SAR Chapter 7, “Installation Design and Structural Evaluation”**RAI NP-7-5:**

SAR Appendix E, “NAC-MPC”**RAI NP-E-8:**

**Figure NP-E-9-1
Location of Node 21856 (MPC-Yankee Rowe)**

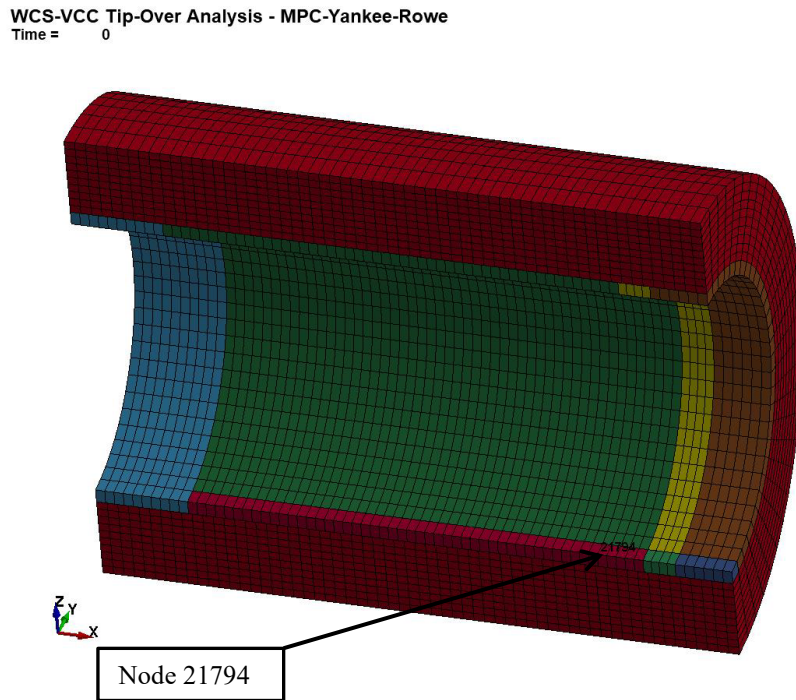
(a) Identify the locations in WCS CISF SAR Figure E.12-2 for which the peak basket accelerations are calculated for evaluating the dynamic load factor (DLF) effects reported in Table E.12-3, "Peak Accelerations and DLF for Yankee Rowe MPC VCC Systems." (b) Provide a sample set of time-history response plots to indicate the time elapsed for which the peak basket accelerations are selected for determining the amplified basket accelerations associated with the short- and long-pulses. [This request also applies to Figure E.12-8 and Table E.12-7 for LACBWR MPC.]

(a) Figure NP-E-9-1 shows the location (Node 21794) at which peak basket acceleration is calculated.

**Figure NP-E-9-3
Time History for Node 21794 (MPC-Yankee Rowe)**

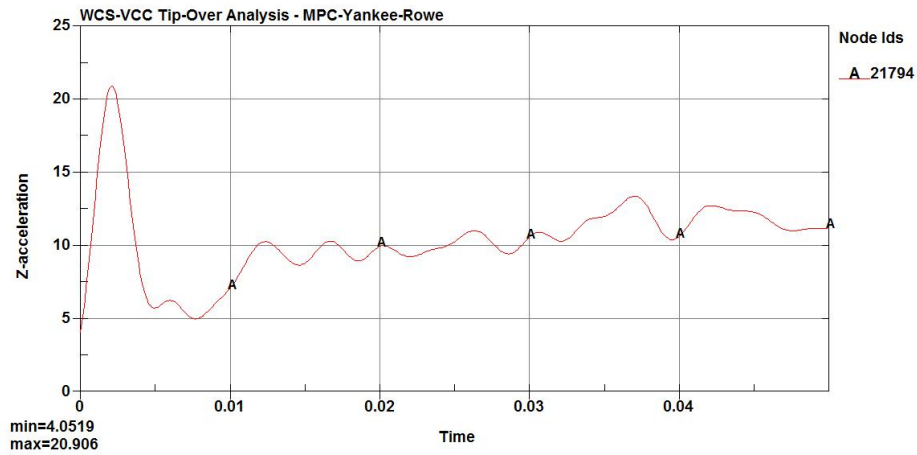
WCS CISF SAR Table E.12-3 lacks information on whether the short- and long- pulse effects reported are associated with the same basket location. If not calculated for the same basket location, discuss the basis for selecting responses at different basket locations for determining the amplified basket responses.

The acceleration time history response at Node 21794 of basket is shown in Figure NP-E-9-3.

The short and long pulse effects reported are associated with the same basket location. (as indicated by node number 21794 in the acceleration time history plot).

Figure NP-F-9-1
Location of Node 63210

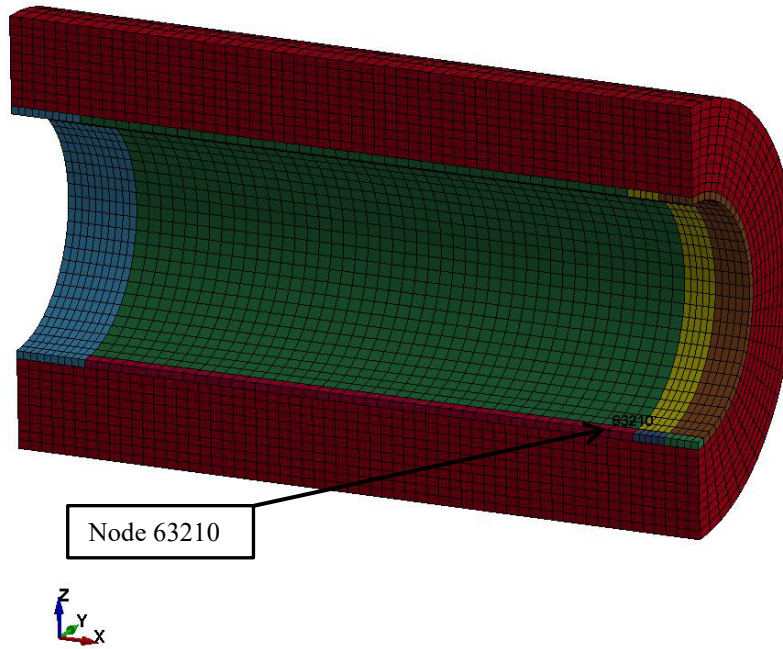
(a) Identify the locations in Figure F.12-2 for which the peak basket accelerations are calculated for evaluating the dynamic load factor (DLF) effects reported in Table F.12-3, "Peak Accelerations and DLF for UMS VCC Systems." (b) Provide a sample set of time-history response plots to indicate the time elapsed for which the peak basket accelerations are selected for determining the amplified basket accelerations associated with the short- and long-pulses. [Note: The request is similar to that discussed previously for the NAC-MPC cask system]

- (a) Figure NP-F-9-1 shows the location (Node 63210) at which peak basket acceleration is calculated.
- (b) As explained in Section F.12.1.3.10 of the WCS CISF SAR, the general pattern of the acceleration time history is shown in Figure F.12-4. Figure NP-F-9-2 below schematically shows the details, where t_1 = elapsed time for short pulse and t_2 = elapsed time for long pulse.

Figure NP-F-9-3
Time History for Node 63210

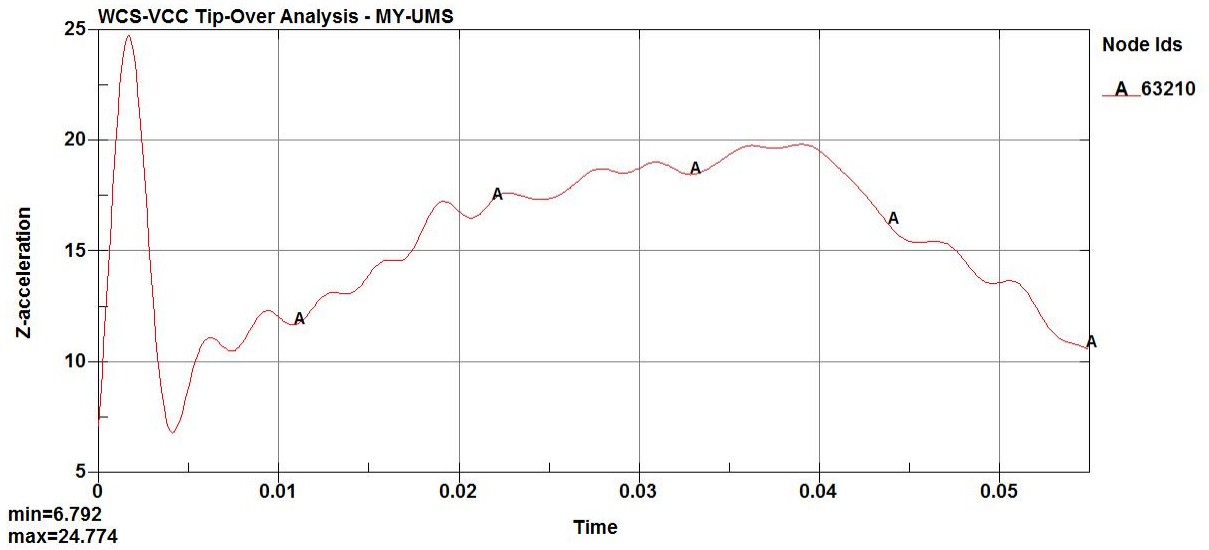
WCS CISF SAR Table F.12-3 lacks information on whether the short- and long- pulse effects reported are associated with the same basket location. If not calculated for the same basket location, discuss the basis for selecting responses at different basket locations for determining the peak amplified basket responses.

The acceleration time history response at Node 63210 of basket is shown in Figure NP-F-9-3.

The short and long pulse effects reported are associated with the same basket location. (as indicated by node number 63210 in the acceleration time history plot).

Figure NP-G-9-1
Location of Node 1355

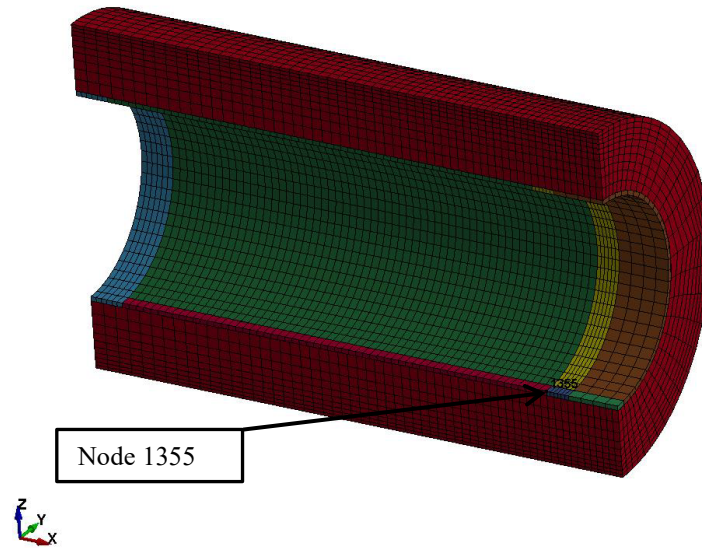
(a) Identify the locations in WCS CISF SAR Figure G.12-2 for which the peak basket accelerations are calculated for evaluating the dynamic load factor (DLF) effects reported in WCS CISF SAR Section G.12.1.3.10, "Determination of Amplified Accelerations." (b) Provide a sample set of time-history response plots to indicate the time elapsed for which the peak basket accelerations are selected for determining the amplified basket accelerations associated with the short- and long-pulses. [Note: The request is similar to that discussed previously for the NAC-MPC cask system]

(a) Figure NP-G-9-1 shows the location (Node 1355) at which peak basket acceleration is calculated.

**Figure NP-G-9-3
 Time History for Node 1355**

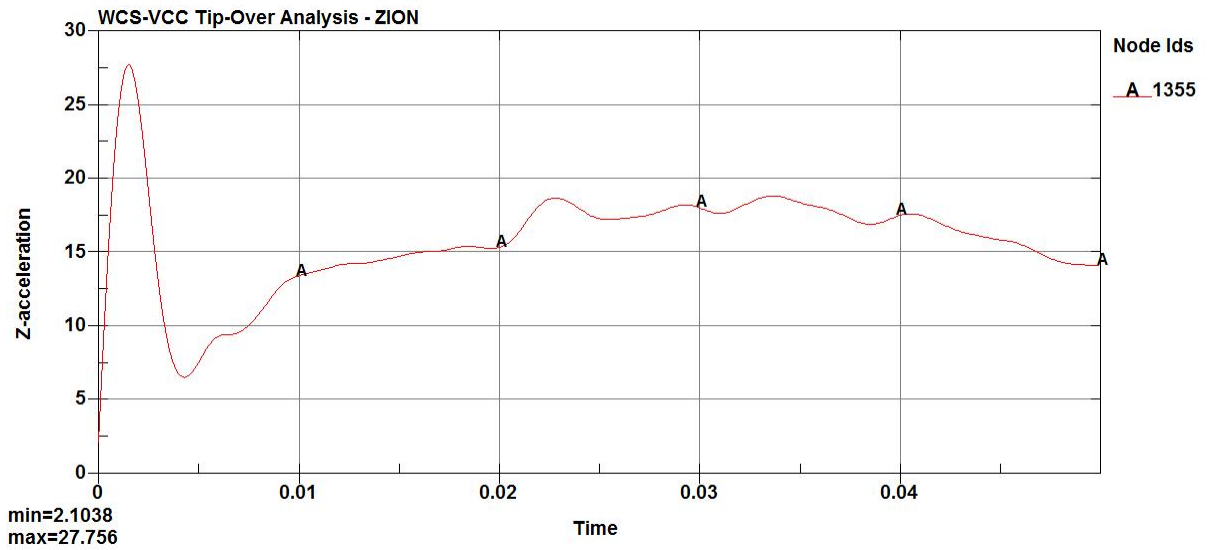
WCS CISF SAR Section G.12.1.3.10 lacks the information on whether the short- and long-pulse effects are associated with the same basket location. If not calculated for the same basket location, discuss the basis for selecting responses at different basket locations for determining the peak amplified basket responses.

The acceleration time history response at Node 1355 of basket is shown in Figure NP-G-9-3.

The short and long pulse effects reported are associated with the same basket location. (as indicated by Node 1355 in the acceleration time history plot).
